## **REMARKS**

An attached replacement drawing sheet(s) and an annotated sheet(s) showing changes to the drawings are attached to this Response as an Appendix. These replacement sheets comprise amendments to Figure 1A. Specifically, reference sign 11 has been removed from the figure. These amendments correct the informalities noted in the objections to the drawings by the Examiner. Accordingly, Applicants respectfully request that all objections to the drawings be withdrawn.

FIG.1A

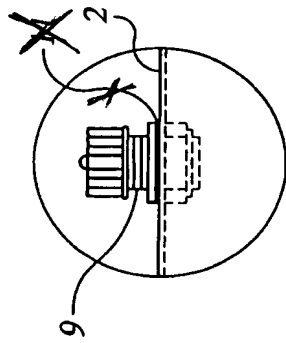
The drawings are objected to for various informalities. As noted above, Figure 1A has been amended to remove reference sign 11. The Examiner also states that the subject matter of claim 5 is not shown in the claims. Applicant respectfully disagrees. The recitations of claim 5 are illustrated in Figures 1 and 2, which show a diaphragm 6 having two ends. As shown, the ends of the diaphragm have a smaller cross-sectional area than a middle portion of the diaphragm, as recited in claim 5. Applicant submits that the figures meet the requirements of 37 C.F.R. §1.84.
